Project Name: *Buc-ee's Site Development Plane*

Project Number: RE2026-137
Date Received: 10/12/2026

Buc-ee's Site Development Plan - Douglas County Referral Comments
Project Number: RE2026-137 (El Paso County Project Number: PPR2628)

Subject: Comments Regarding the Proposed Buc-ee's Project

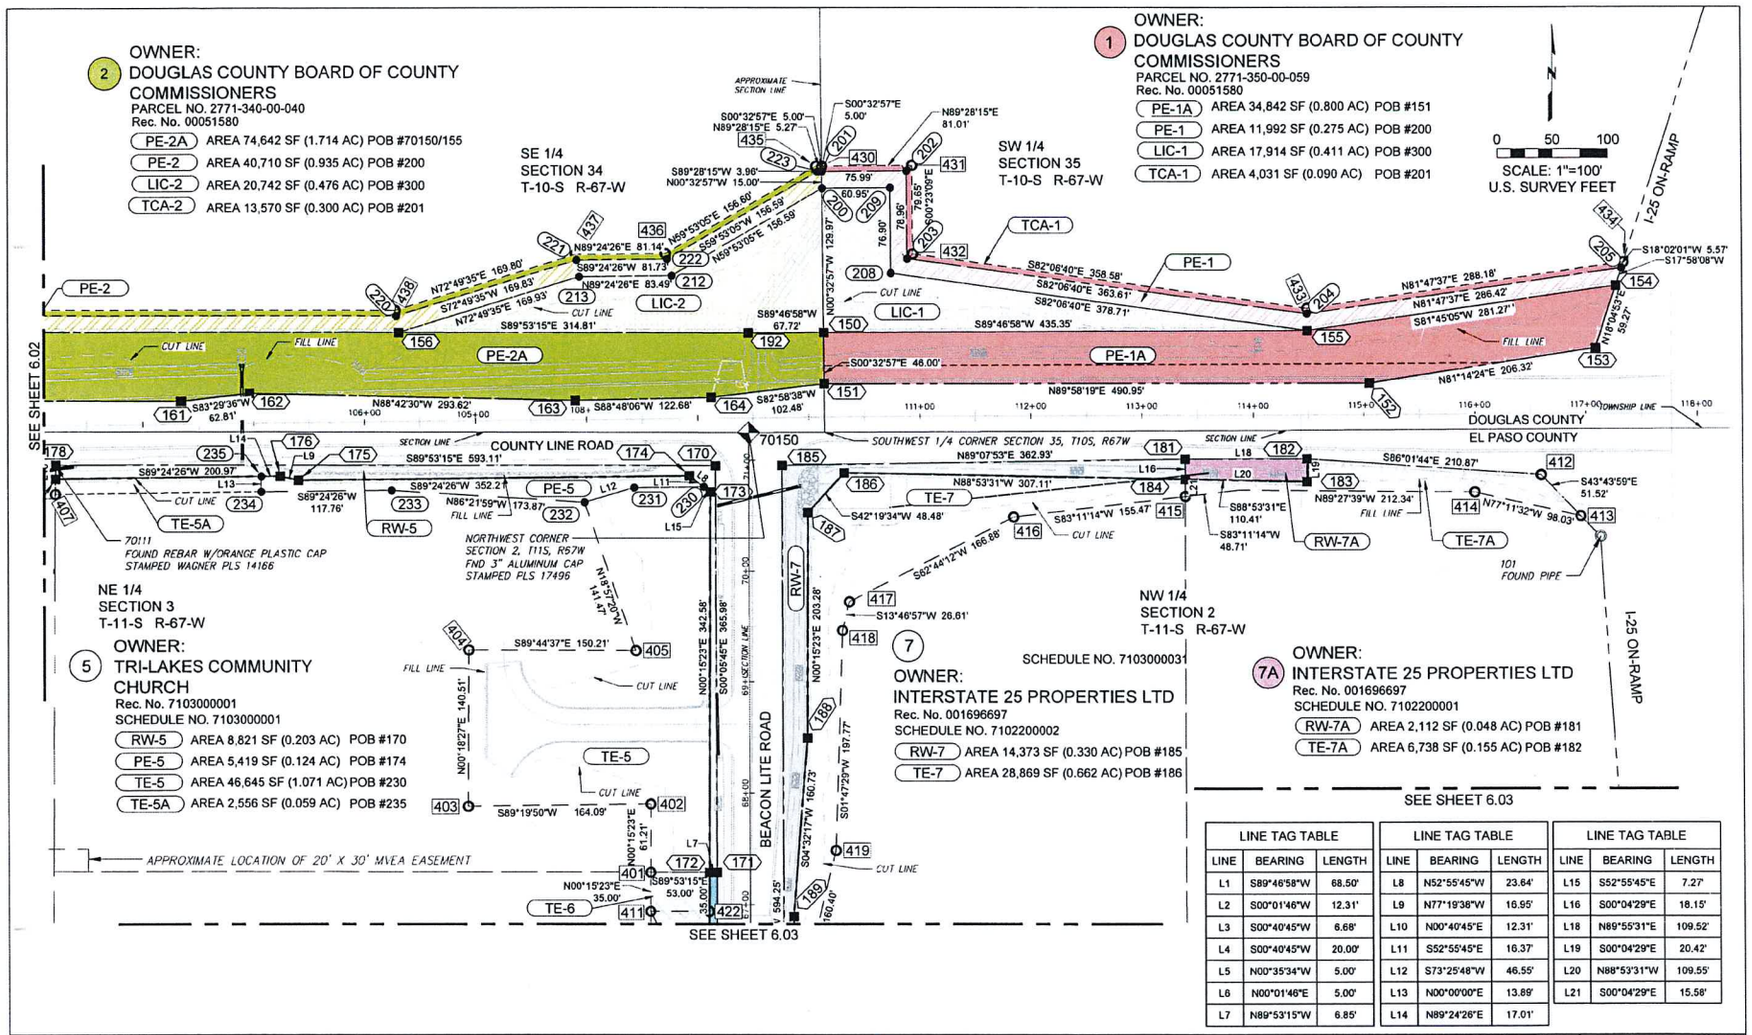
4. The existing permanent easement area and the license agreement governing grading for the County driveway do not appear to be shown correctly in the project documents. Please refer to the attached exhibit, which depicts the condemned permanent easement area and the license agreement area.
